ARCHITECHNICS, INC.
510 MAINE STREET
QUINCY, ILLINOIS 62301

PROJECT NO. : 6454

ADDENDUM NO.: 1
ISSUED: 10/27/2023

Project: New Dry Fertilizer Storage Building
Frankford Farm Services
Frankford, MO

6 STRUCTURAL SECTION
 SCALE: 3/4" = 1'-0"

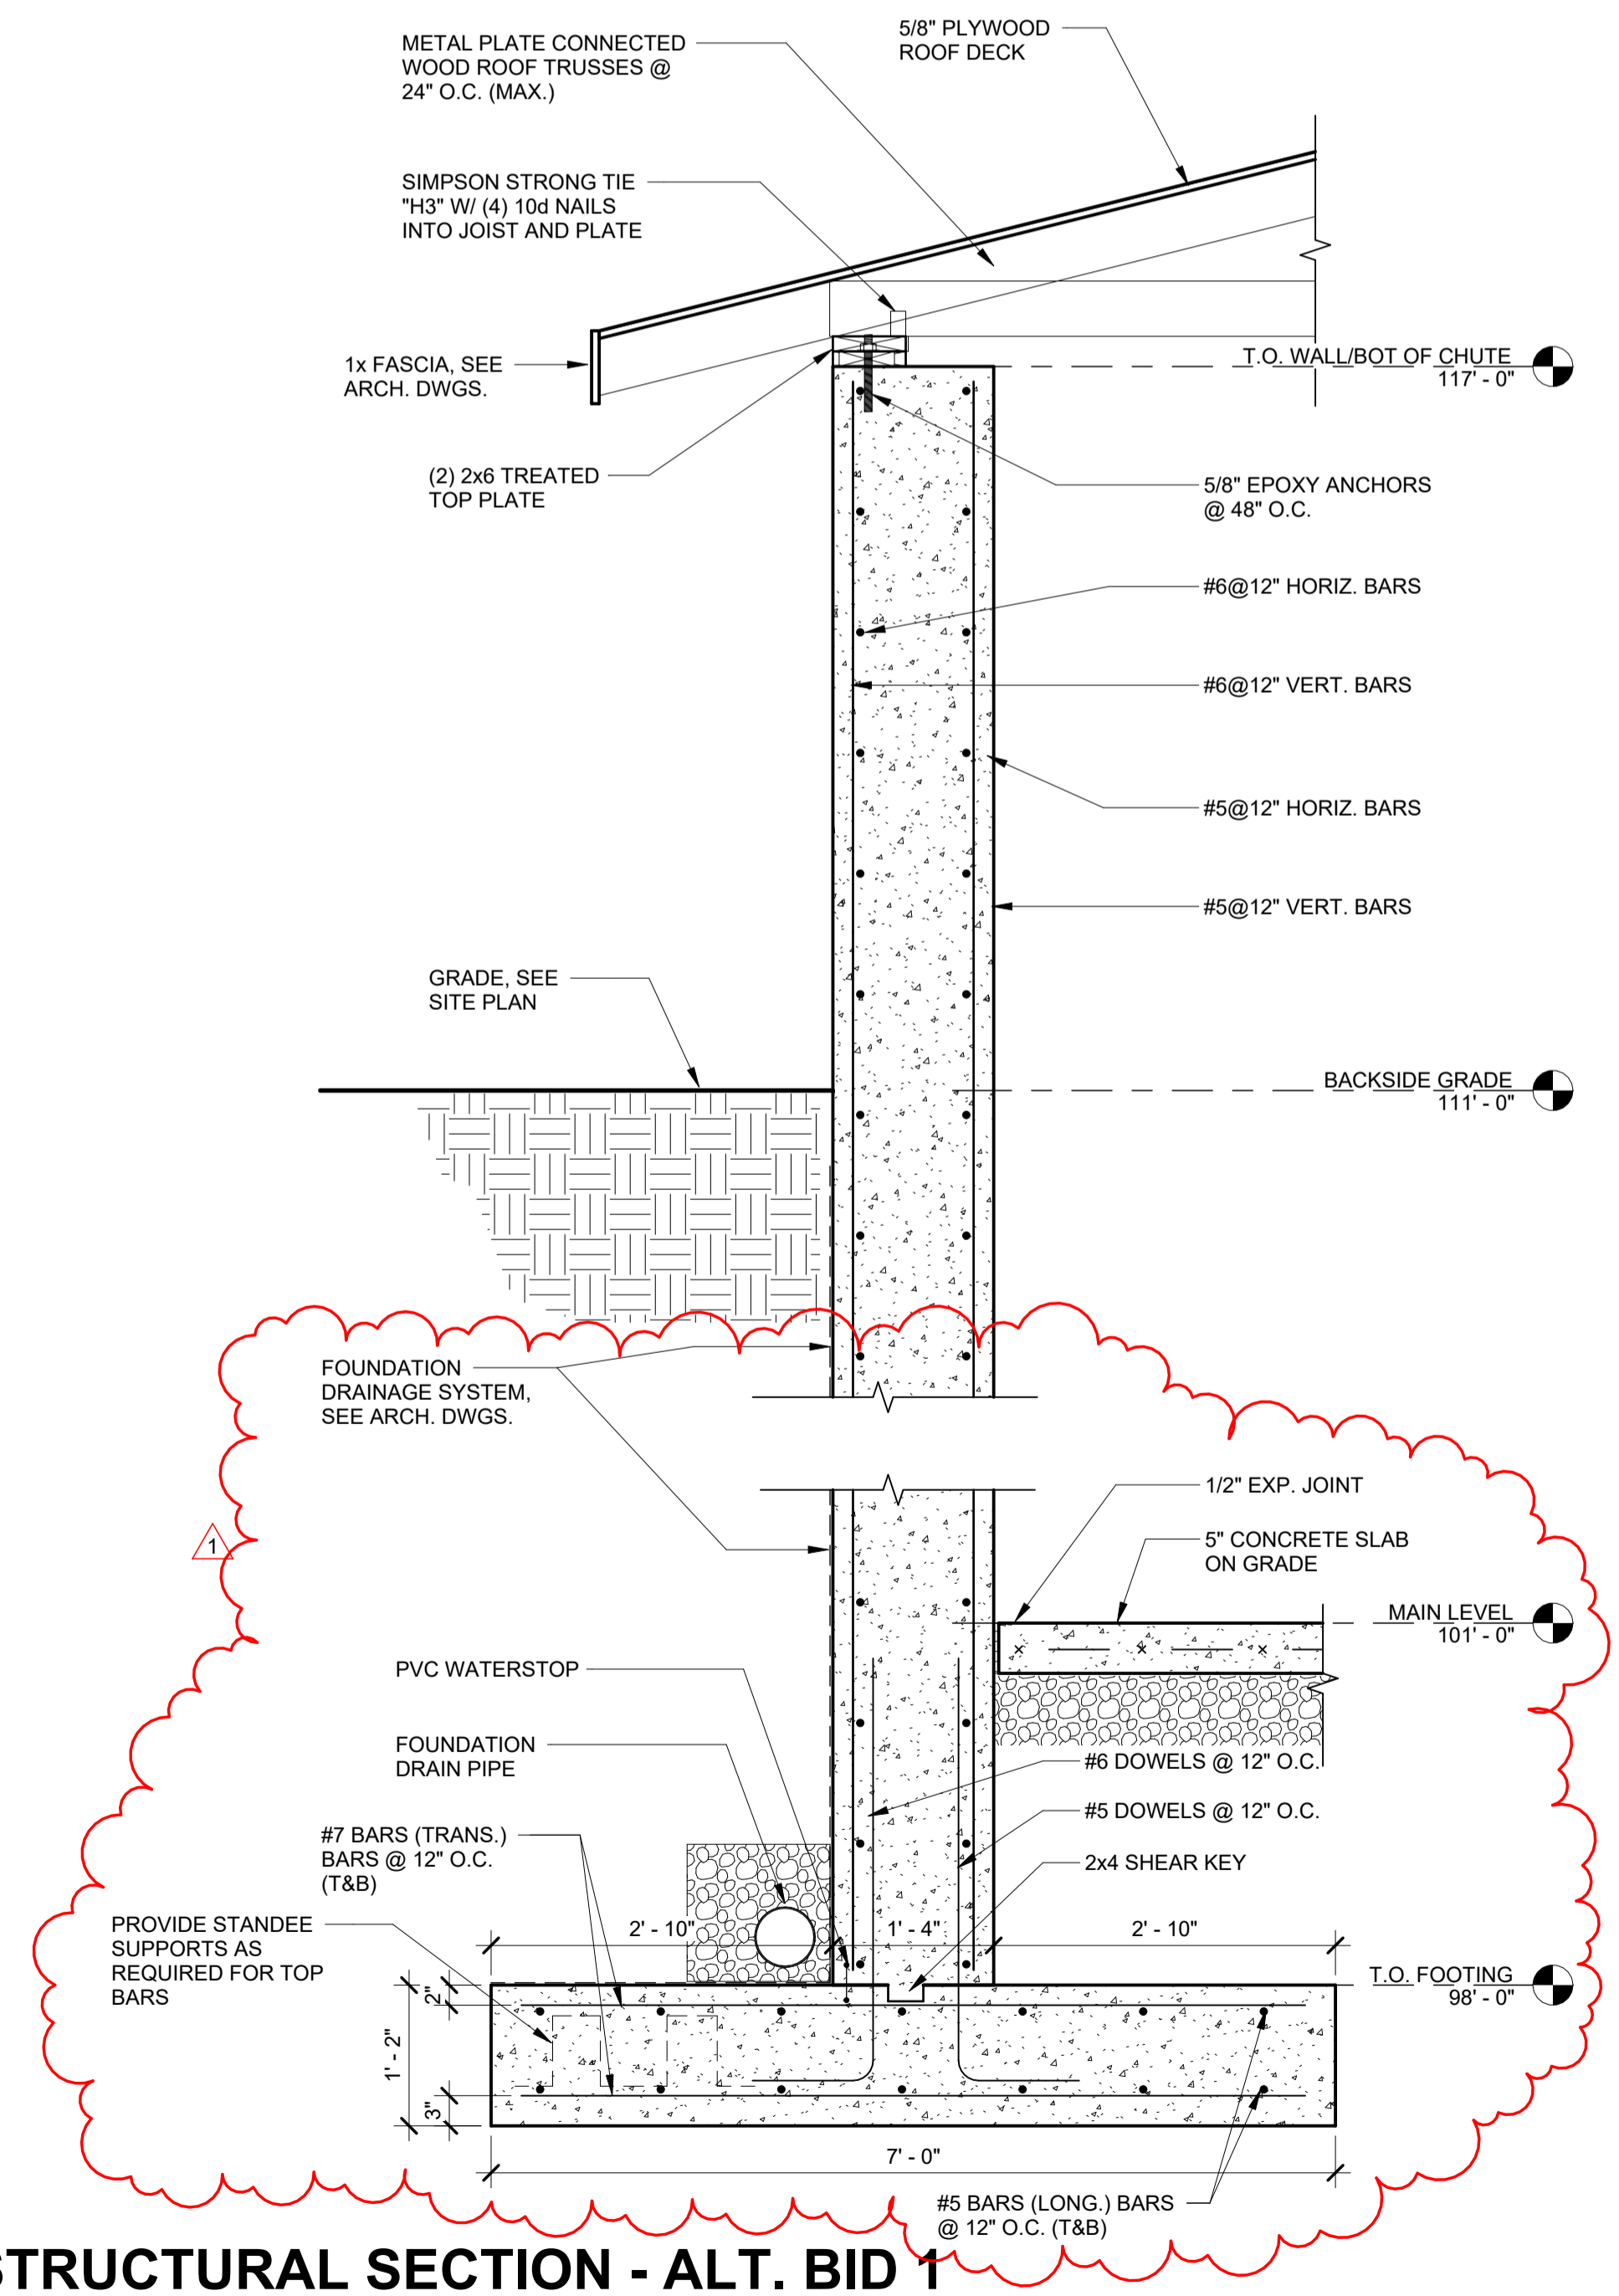
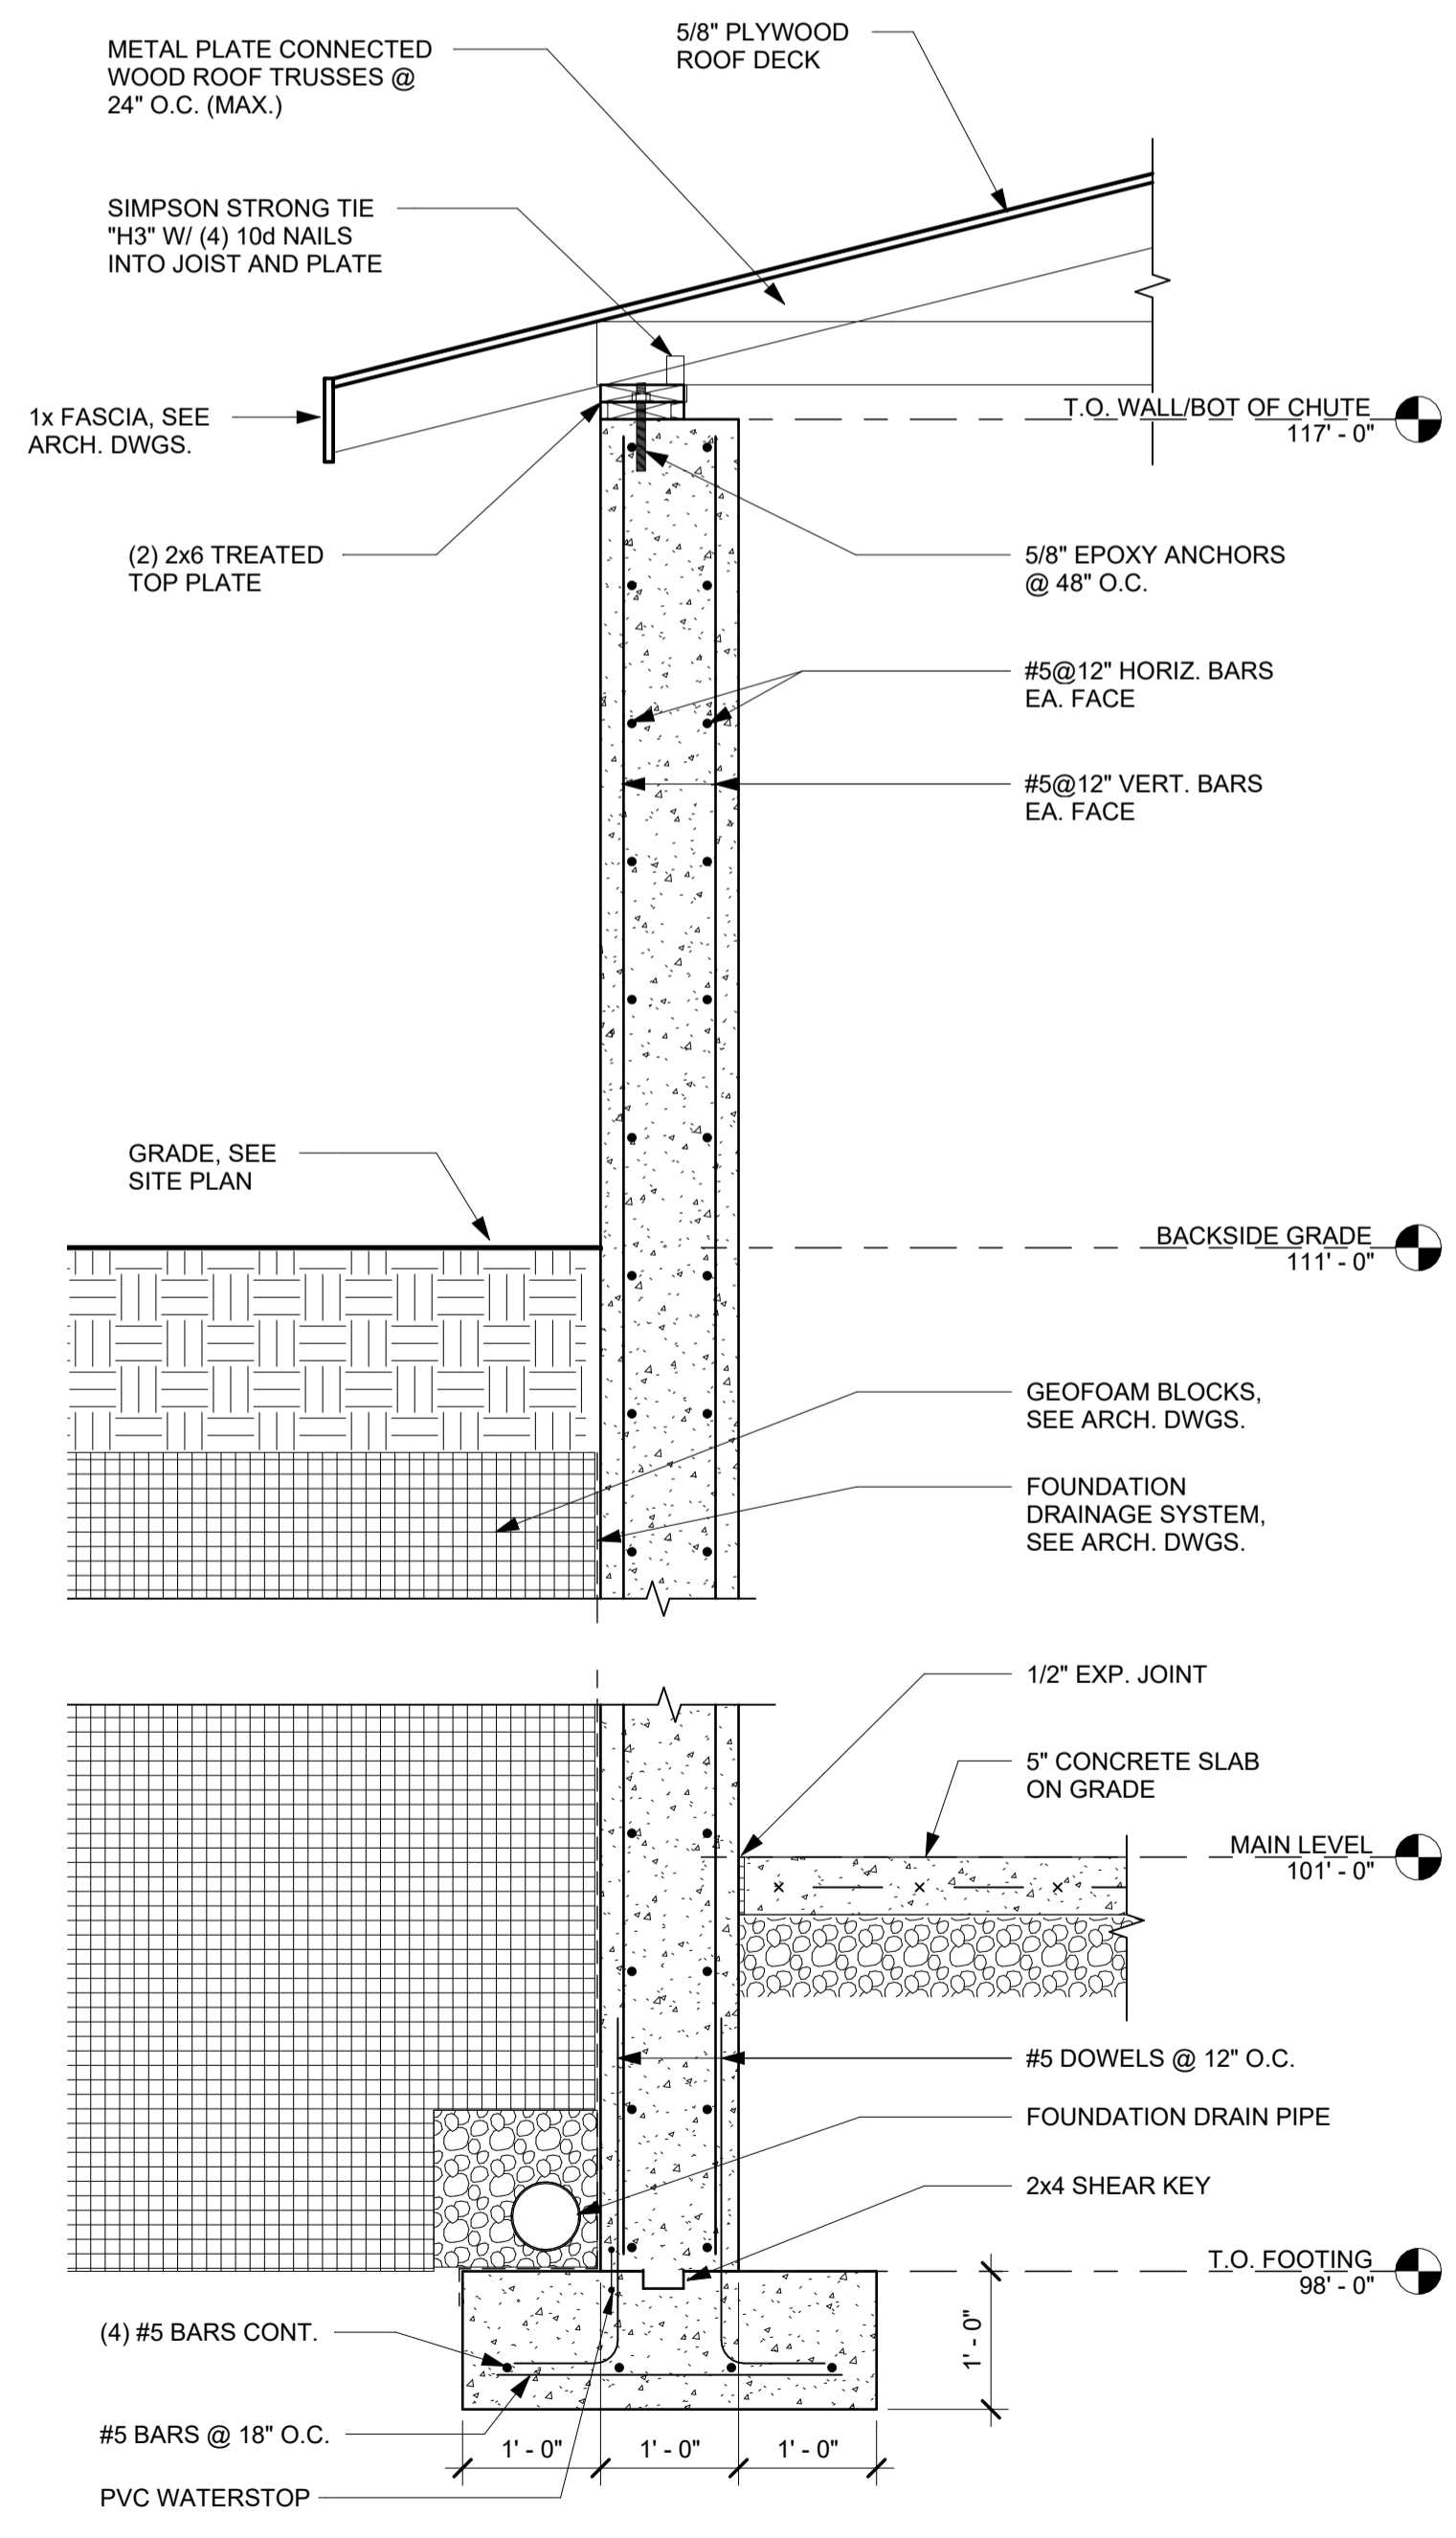
ITEM	DESCRIPTION
<u>Clarify</u>	
1.0	Clarify Omit any references to Hanson Silo Tee Panels in the specifications or on the drawings. Refer to bidding notes on sheet G000 for various panel construction type (cast in place or conventional precast)
2.0 6/S202 Structural Details	Clarify The same footing as shown on Dtl 6/S202 shall be used for both Base Bid 1 and Base Bid 2. For Base Bid 2 add weld plates per precast concrete wall manufacturer recommendations.
<u>Drawings</u>	
1.0 S101 Foundation Plan	Replace Replace with attached revised sheet.
2.0 S202 Structural Details	Replace Replace with attached revised sheet.
3.0 A101 Floor Plan	Replace Replace with attached revised sheet.
4.0 A201 Building Elevations	Replace Replace with attached revised sheet.
5.0 A301 Building Sections	Replace Replace with attached revised sheet.

1 FLOOR PLAN
 SCALE: 1/4" = 1'-0"

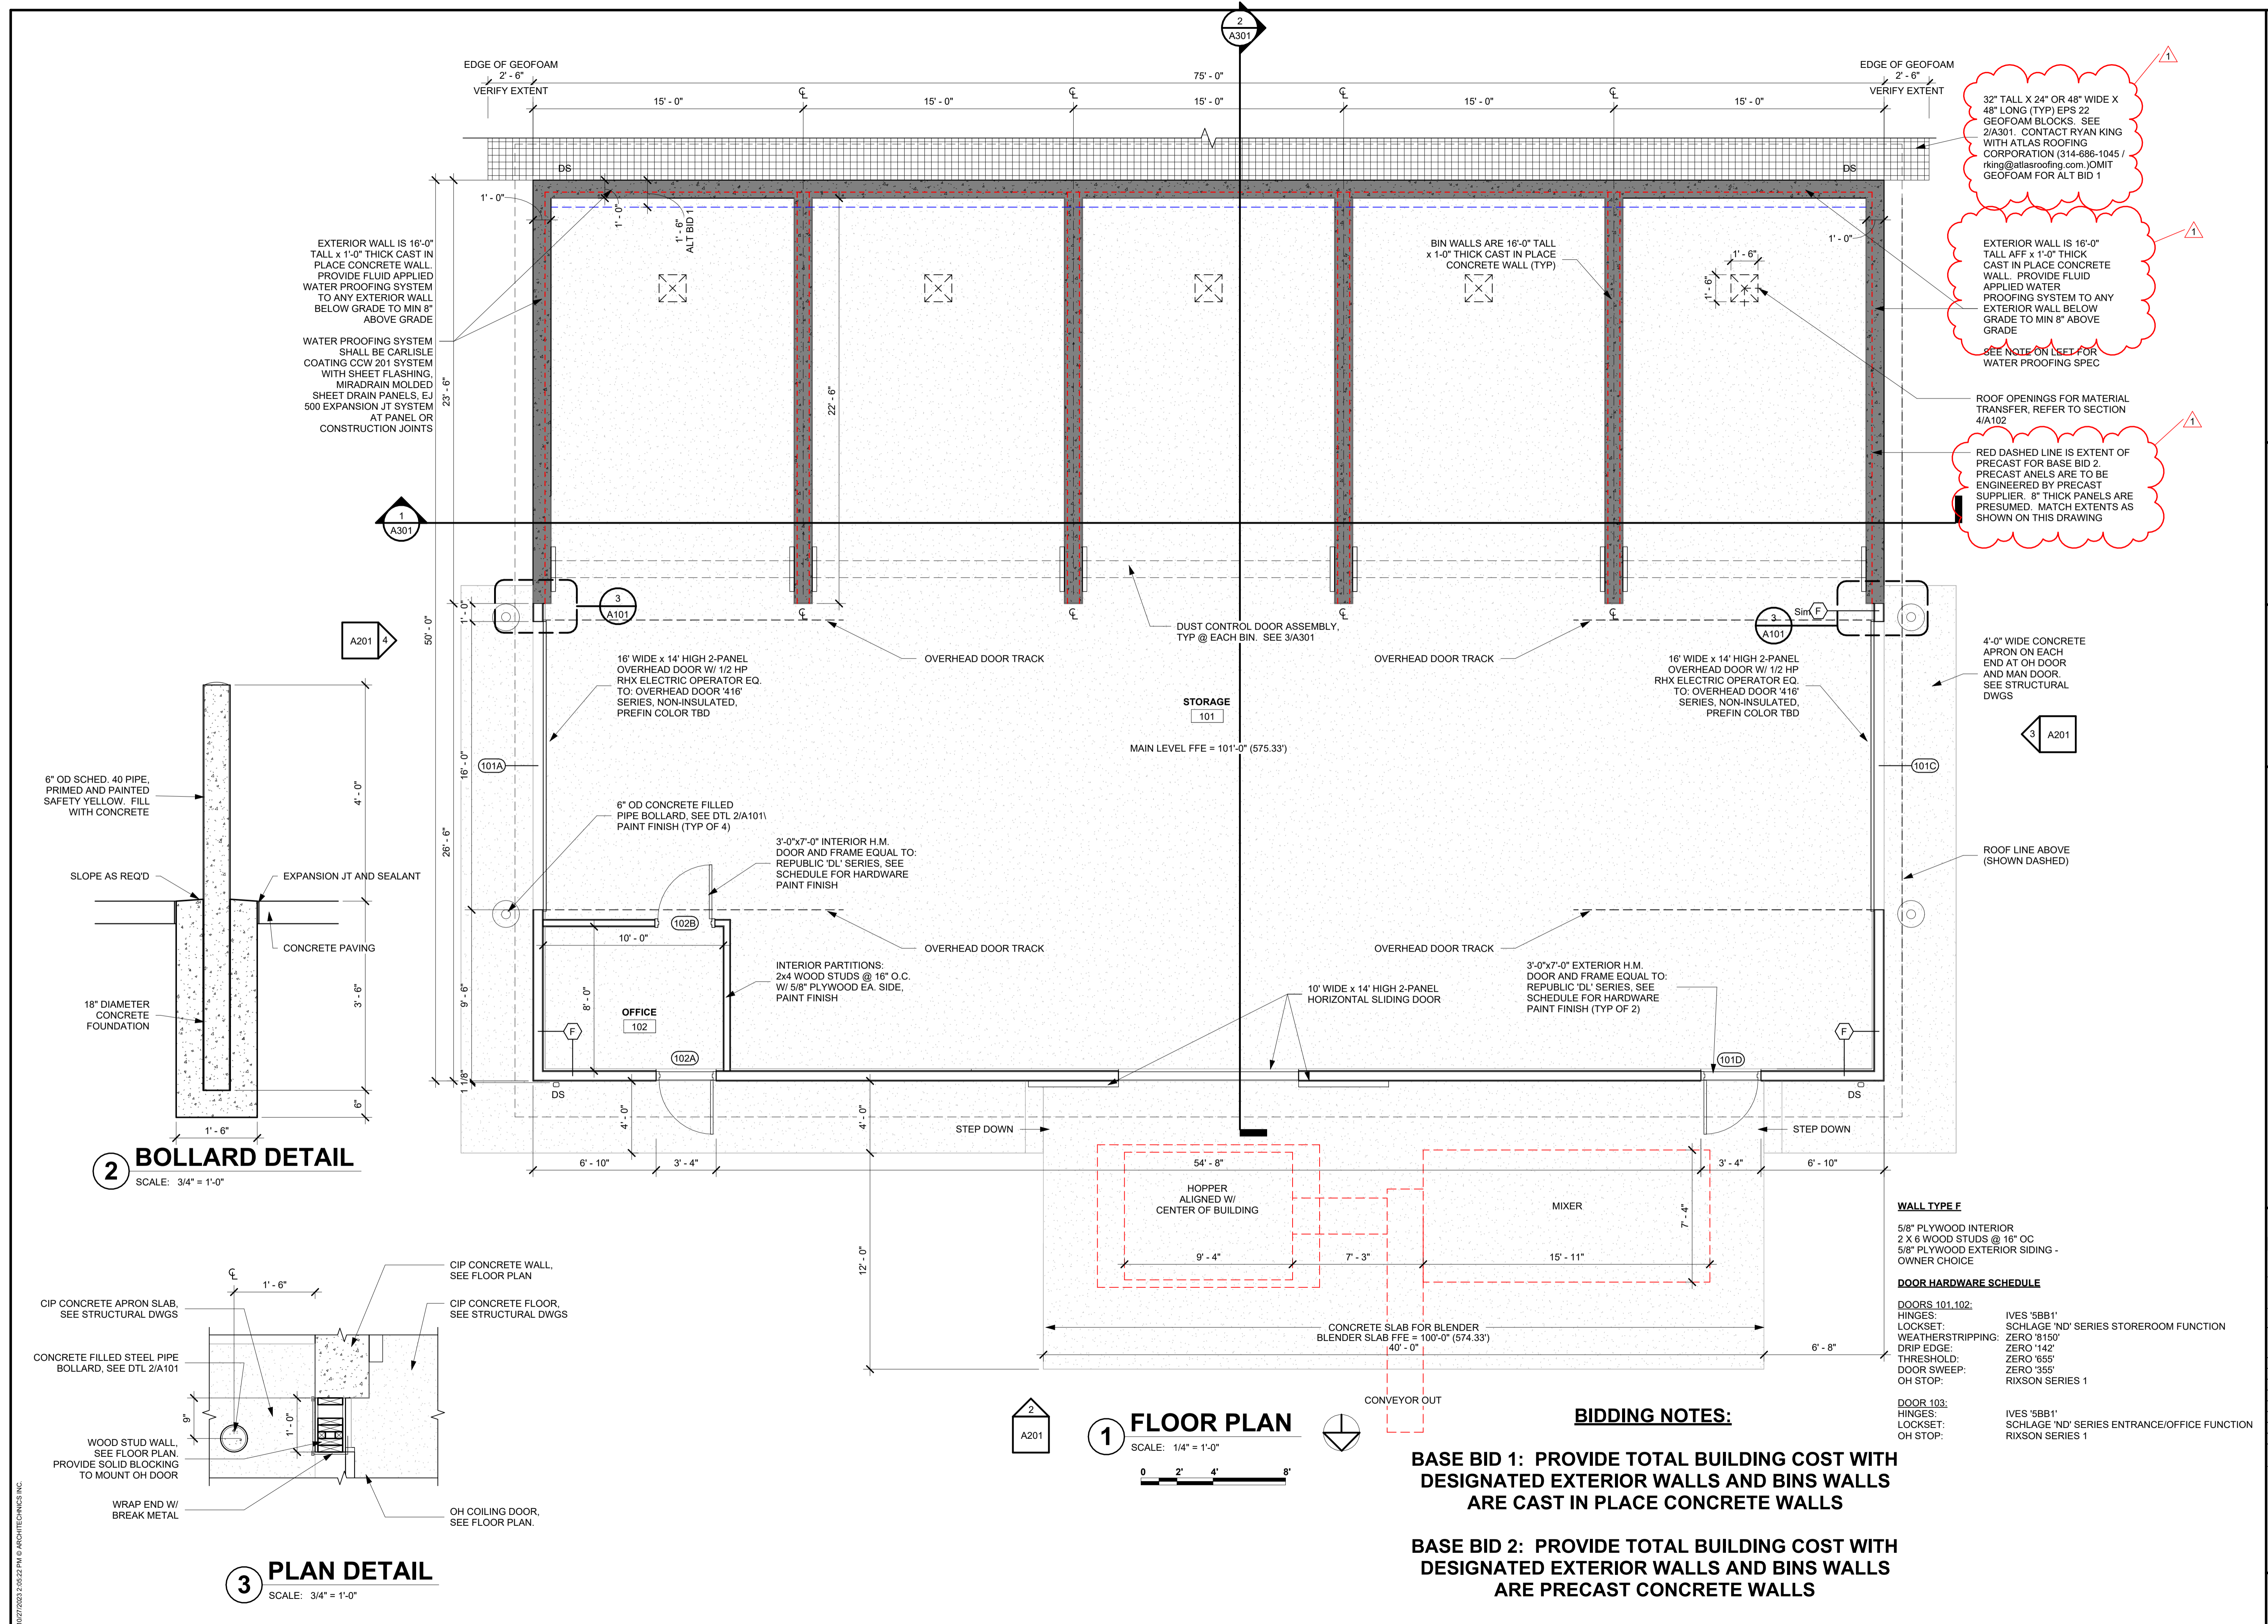
32" TALL X 24" OR 48" WIDE X 48" LONG (TYP) EPS 22 GEOFOAM BLOCKS. SEE 2/A301. CONTACT RYAN KING WITH ATLAS ROOFING CORPORATION (314-686-1045 / rking@atlasroofing.com.) OMIT GEOFOAM FOR ALT BID 1

ROOF OPENINGS FOR MATERIAL TRANSFER, REFER TO SECTION 4/A102
 RED DASHED LINE IS EXTENT OF PRECAST FOR BASE BID 2. PRECAST PANELS ARE TO BE ENGINEERED BY PRECAST SUPPLIER. 8" THICK PANELS ARE PRESUMED. MATCH EXTENTS AS SHOWN ON THIS DRAWING
